# HILLSIDE NURSERIES, BURY

# PLANNERS' FEEDBACK OF INITIAL SCHEME

# INITIAL COMMENTS TAKEN AT THE PRE APP MEETING WITH THE PLANNERS

# FORMAL ECE REVISED SITE PLAN TO ADDRESS INITIAL PLANNERS COMMENTS

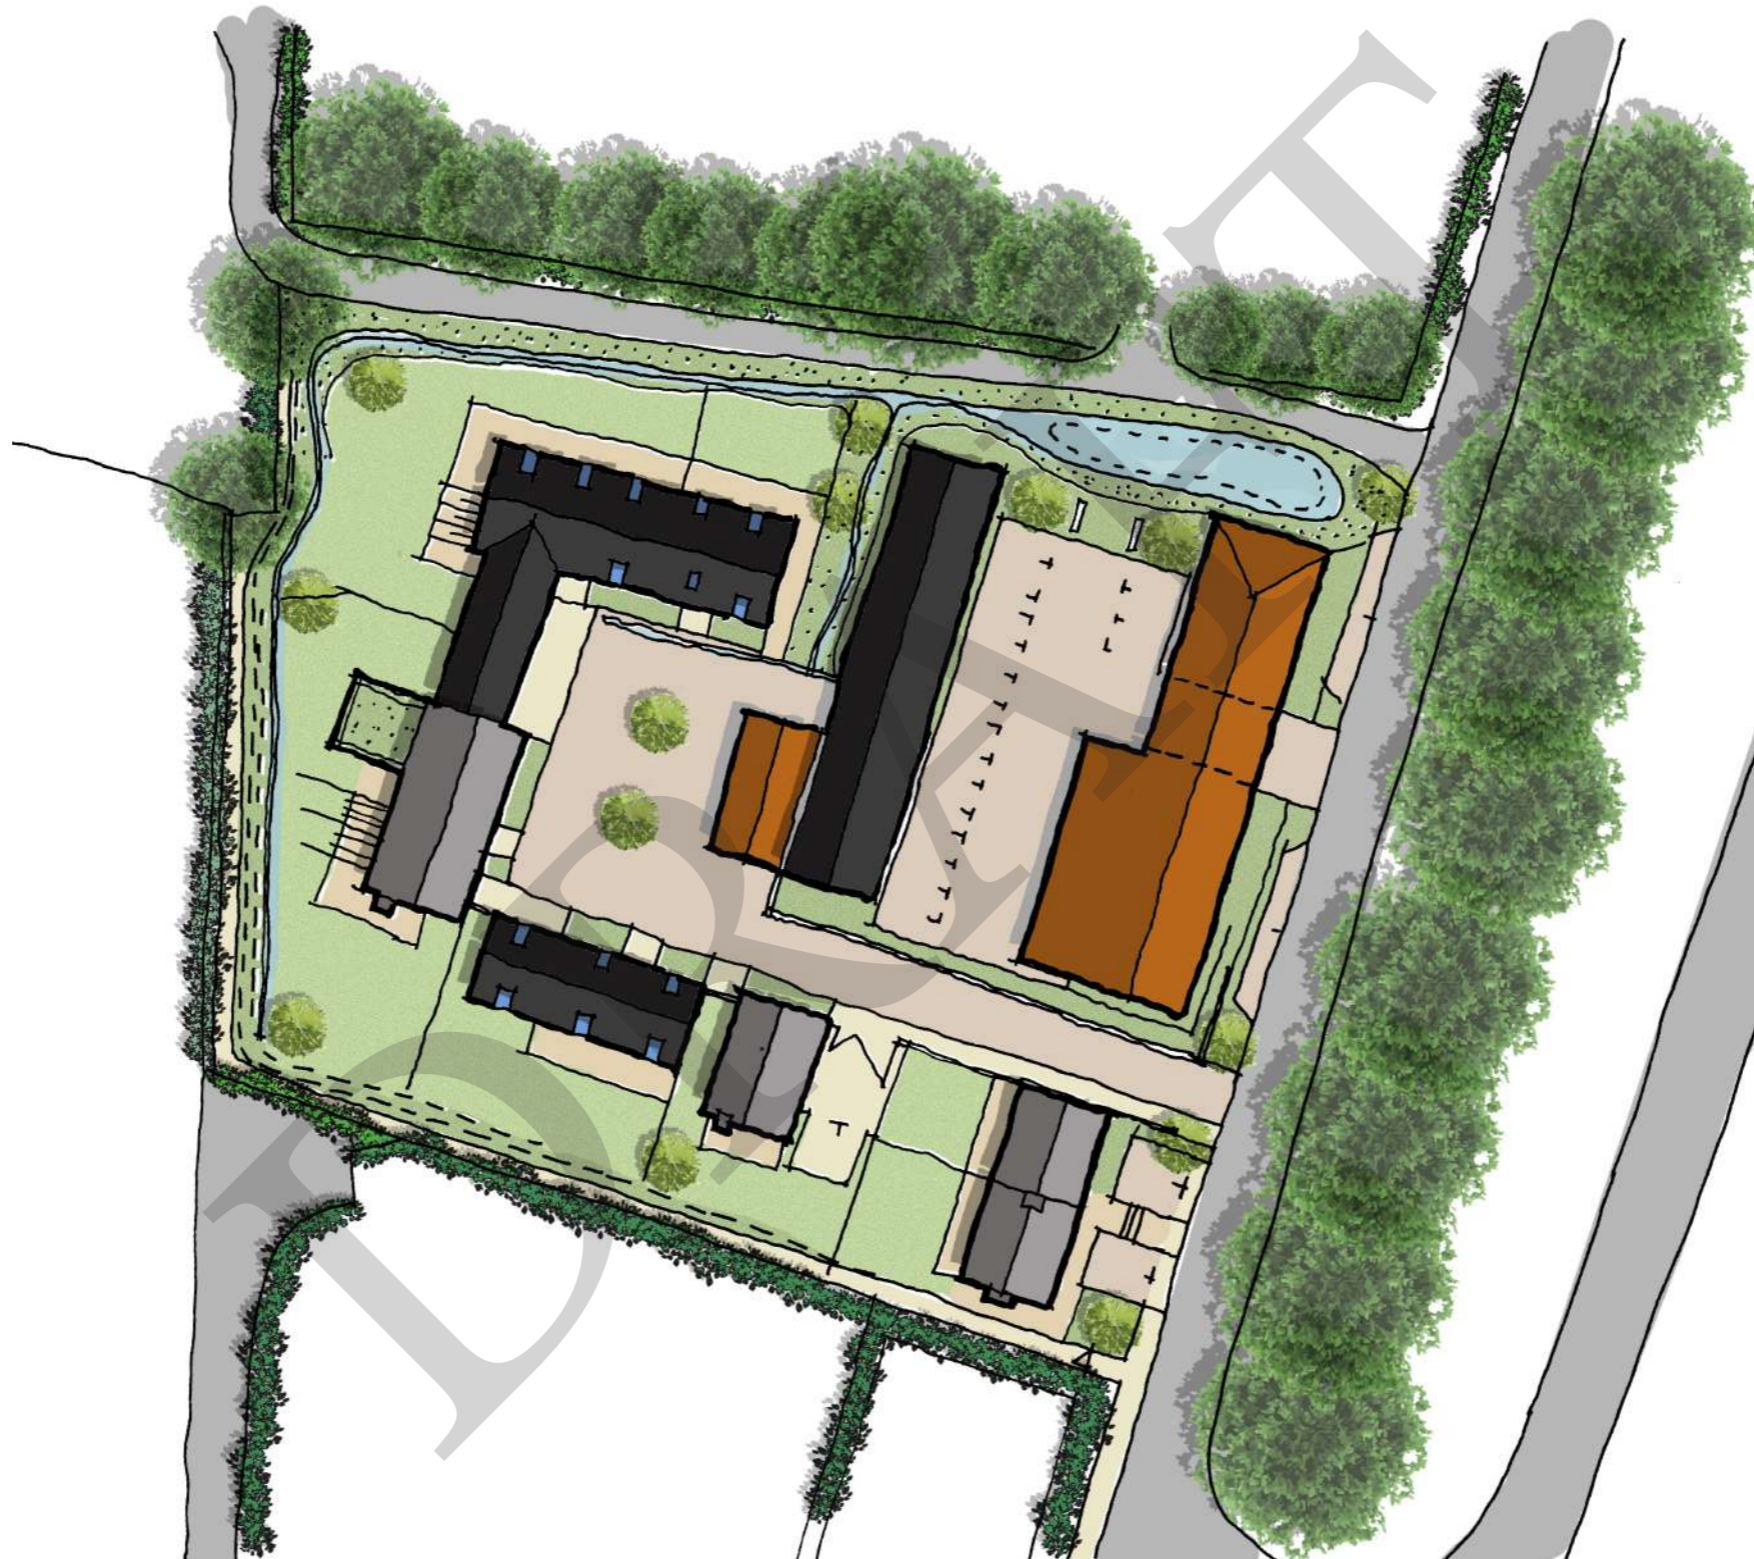
1. Maintenance strip to the west and southern boundary encouraged. Possible addition native hedge to the southern hedge.

2. Provide a landscaped buffer to the northern edge not a timber fence. Include a swale detail along the road edge as part of the green infrastructure strategy.

3. Towards the north east edge maybe provide a more open corner to the site in and around the attenuation pond.

4. Revisit the field pattern and use this for the green/blue infrastructure strategy.

8. The current layout could be less ridged and more organised and less formal, a sense of historic ad-hoc design, developed over time.

9. The courtyard will act as refuse vehicle turning space. Servicing strategy required for refuse, vehicle turning and emergency vehicles, deliveries etc.

10. Blue and Green strategy to be refined with input from drainage engineer. To include swales, rills etc and not a piped solution.

11. Development needs to be away from the sensitive western boundaries and has to include the maintenance strip and any verges/swales

12. Move the commercial building further to the east.

13. Opportunity to splay the commercial buildings further to open up views to the north attenuation pond.

14. Review access hierarchy, primary and secondary access

15. Review parking arrangement to the front of the cottage. Possible single access with hedge, wall and verge, small courtyard parking.

1. Maintenance strip added
2. Landscape buffer and swale added. Discussions required with neighbour on extent of proposed privacy timber fence
3. low level landscape buffer to the north of the attenuation pond

4. Field pattern used as part of the green and blue infrastructure
5. Farmstead Typology and character of the site retained and strengthened
6. Referencing the nuances of Bury would add merit to the scheme. TBC

7. LVIA scoping and mythology and evidence. Further input from landscape architect required based on current layout
8. Arrangement of building more organise and ad-hoc

9. The courtyard will act as refuse vehicle turning space. Servicing strategy required for refuse, vehicle turning and emergency vehicles, deliveries etc.

10. Blue and Green strategy to be refined with input from drainage engineer. To include swales, rills etc and not a piped solution.
11. Clear separation from built form and boundaries

12. Commercial building moved closer to the road with the introduction of a verge
13. Commercial units splayed to aline with field pattern and views toward teh attenuation pond

14. There is a clear hierarchy of highway access

15. Parking for the cottages moved to the side with a single entrance walled courtyard and rear access
16. Opportunity to create a contemporary development based on the contextual analysis of Bury. TBC

17. Green roof - Added to development.
18. Passive House - ECE to provide options for a passive standard not accredited using traditional construction.  
ECE to review existing energy statement and provide comments with new layout.

Drawing Title  
 Site Plan Sketch 1

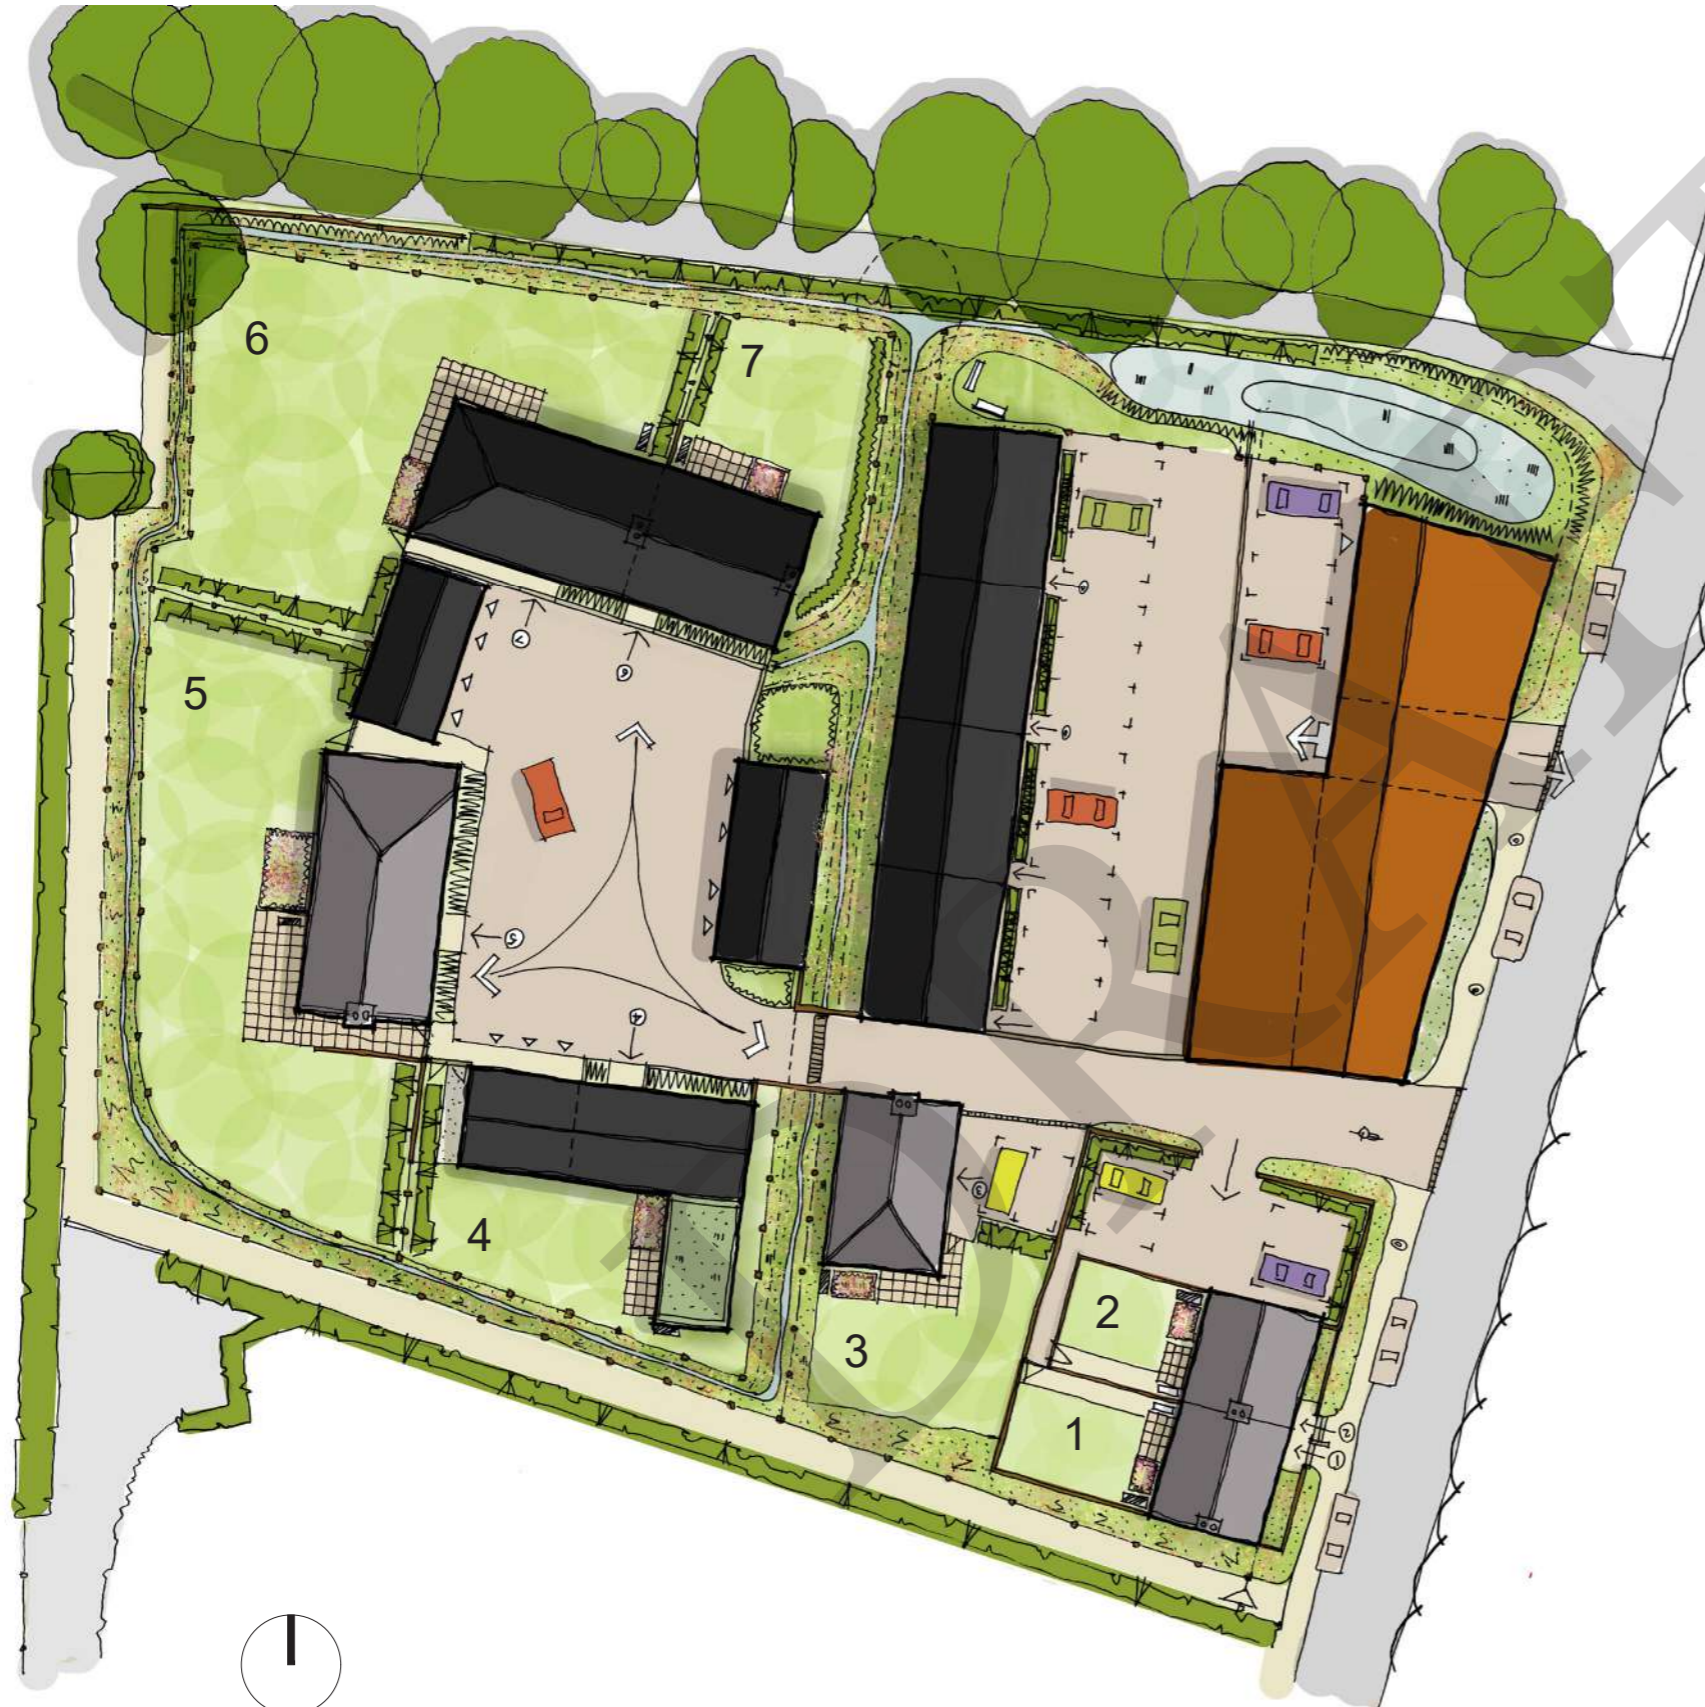
2. Provide a landscaped buffer to the northern edge and limit the use of timber close boarded fence. Include a swale along the boundary as part of the green/blue infrastructure strategy.

3. Towards the northeast edge provide a more open corner to the site in and around the attenuation pond.
4. Revisit the field pattern and use this for the green/blue infrastructure strategy.

22. More detail is required on how the site responded to the existing levels on site.
23. More detail is required on the roof line of the development when viewed from the Coffin Trail.

1. Maintenance strip to the boundary edge included
2. Landscape buffer and swale added. Discussions are ongoing with the neighbour to the northeast on the extent of the proposed privacy timber fence. Client and landscape architect to explore

3. low-level landscape buffer to the north of the attenuation pond is to be reviewed with the landscape masterplan
4. Field pattern informing the green and blue infrastructure

5. Farmstead typology and character of the site retained and strengthened
6. LVIA. Landscape architect to provide masterplan strategy.
7. Arrangement of buildings more organic. The configuration responds to contours, historic field patterns and typology

20. Detail on how the site responded to the existing levels on site will be included within the final design with input from design consultants.
21. ECE to review the roof line when viewed from the Coffin Trail within the new housing design/site arrangement.
